Rezoning Transportation Analysis

Petition Number: 2025-021

General Review Information

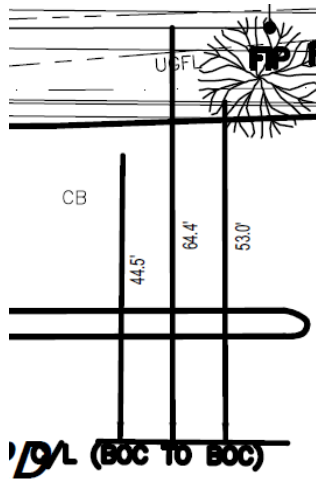
- a. ~~E WT Harris Boulevard: The future location of the back of curb and gutter is 33' from road centerline. The existing curb must be relocated to the future back of curb.~~

~~4+ Boulevard with 12' shared use path and 8' planting strip.~~

~~Label and dimension the curb and gutter from the centerline for each road on the site plan.~~

Clarifying comment 5.21.25: ~~The dimension for the road centerline should start in the middle of the median along E WT Harris to the back of existing curb and gutter / proposed curb and gutter location. This will be much less than the dimension currently shown. Please clearly label the dimensions. In screen shot below, it is unclear what the 44.5', 53.0', and 64.4' is dimensioning.~~

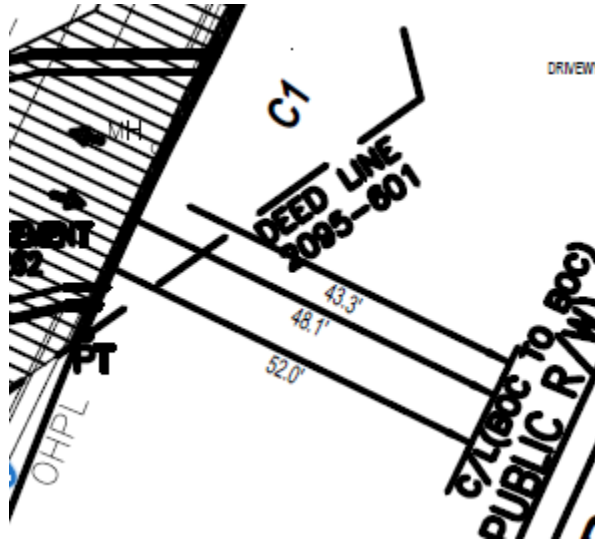
- b. ~~Idlewild Road: The future location of the back of curb and gutter is 38' from road centerline. The existing curb and gutter can remain.~~

4+ Avenue with buffered/separated bike lanes and 6' sidewalk/8' planting strip.

Label and dimension the curb and gutter from the centerline for each road on the site plan.

Clarifying comment 5.21.25: Please clearly label the dimensions. In screen shot below, it is unclear what the 43.3', 48.1', and 52' is dimensioning.

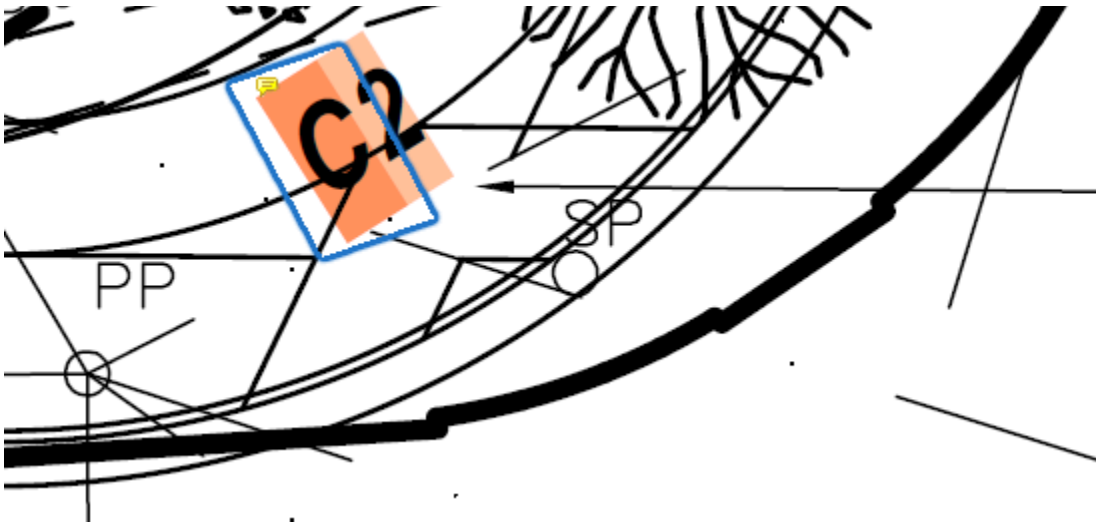
6. ~~Advisory for the adjustment of the proposed 8' sidewalk along Idlewild Road since the Charlotte Streets Manual only requires 6'.~~

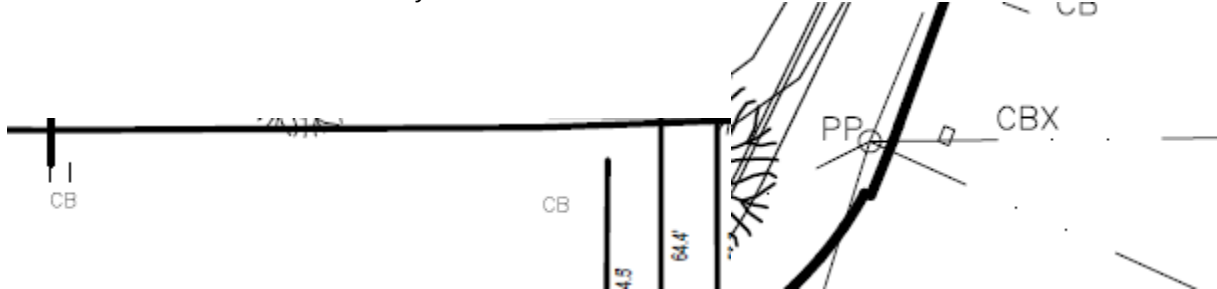
13. ~~New Comment 5.21.2025: Please fix conditional notes to stipulate that a 8' planting strip and 6' sidewalk is required along Idlewild.~~

~~12' shared use path along E WT Harris Boulevard and Idlewild road~~

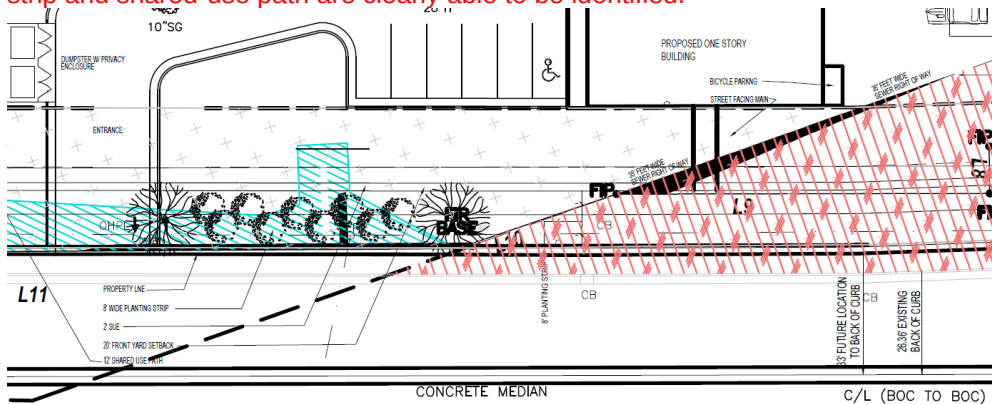
14. ~~New Comment 5.21.2025:~~ Check site plans especially the proposed property line — it is not matching with what is shown on our GIS maps
15. ~~New Comment 5.21.205:~~ Check site plans for accuracy. Currently, catch basin and power pole are shown in the middle of roadway.

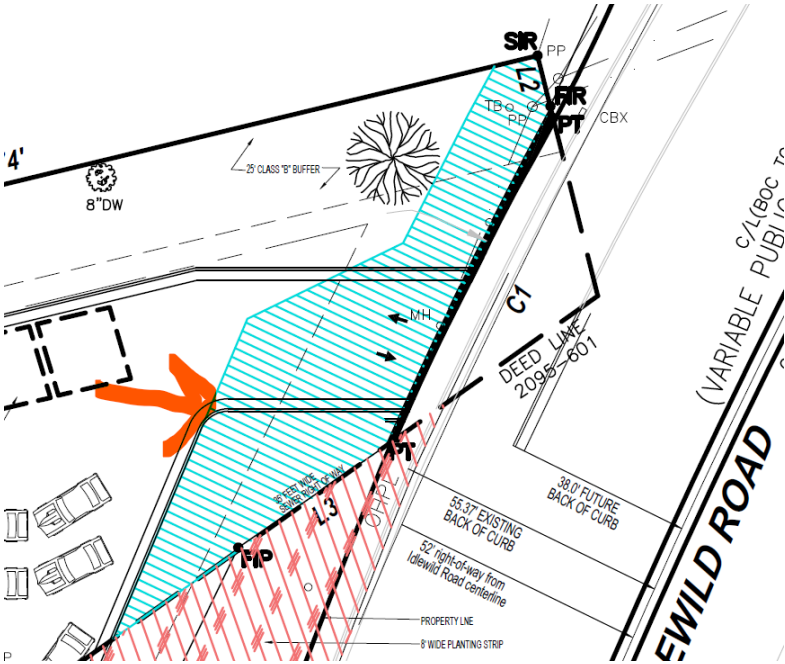
16. **Outstanding Comment from 7.22.25:** Please lighten or remove hatching so the proposed planting strip and shared-use path are clearly able to be identified.

UPDATED COMMENT 09-23-25: Remove red and blue hatching to clarify the site plan and delineate linework to identify frontage improvement.

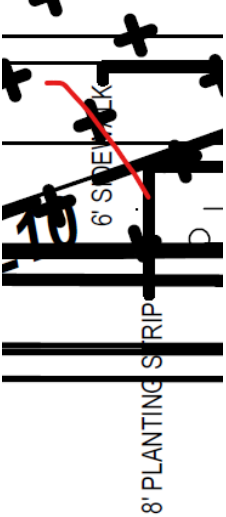
19. ~~New Comment 8.20.25: It is not clear what hatched area below represents. Identify what this area is to represents. Place hatching in legend with description.~~

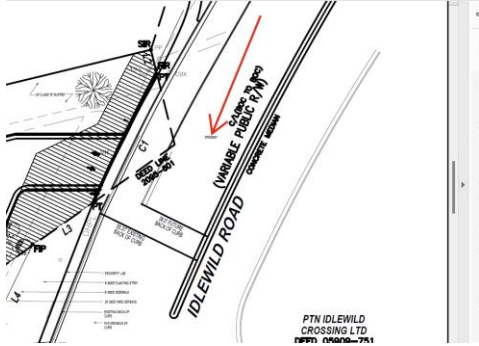
24. **New Comment 8.20.25:** ~~Remove "driveway" from conditional note #9 and #10 since CDOT does not require a driveway permit. Revise notes to say"~~

~~9. "The proposed driveway connection(s) to public streets will require permit(s) to be submitted to CDOT for review and approval. The exact driveway location(s) and type/width of the driveway(s) will be determined by CDOT during the permitting phase. The locations of the driveway(s) shown on the site plan are subject to change in order to align with driveway(s) on the opposite side of the street and comply with City Driveway Regulations and the City Tree Ordinance."~~

~~10. "All proposed commercial driveway connections to a future public street will require a permit submitted to CDOT for review and approval."~~

9. The proposed driveway connection(s) to public streets will require a driveway permit(s) to be submitted to CDOT for review and approval. The exact driveway location(s) and type/width of the driveway(s) will be determined by CDOT during the driveway permit process. The locations of the driveway(s) shown on the site plan are subject to change in order to align with driveway(s) on the opposite side of the street and comply with City Driveway Regulations and the City Tree Ordinance.

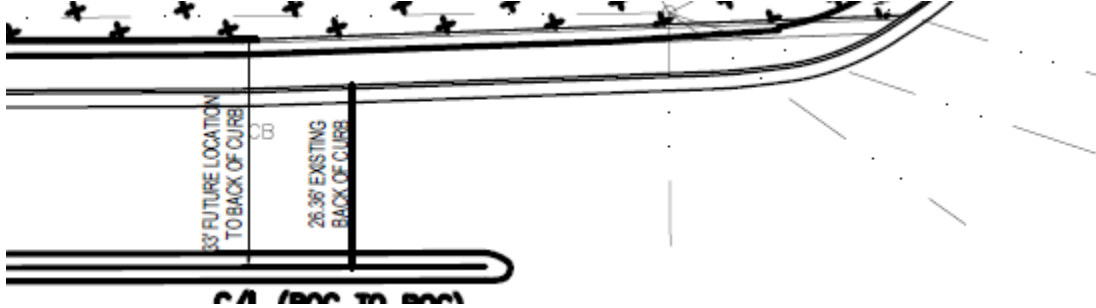
~~26. **New Comment 8.20.25:** Remove driveway label from the middle of the roadway.~~
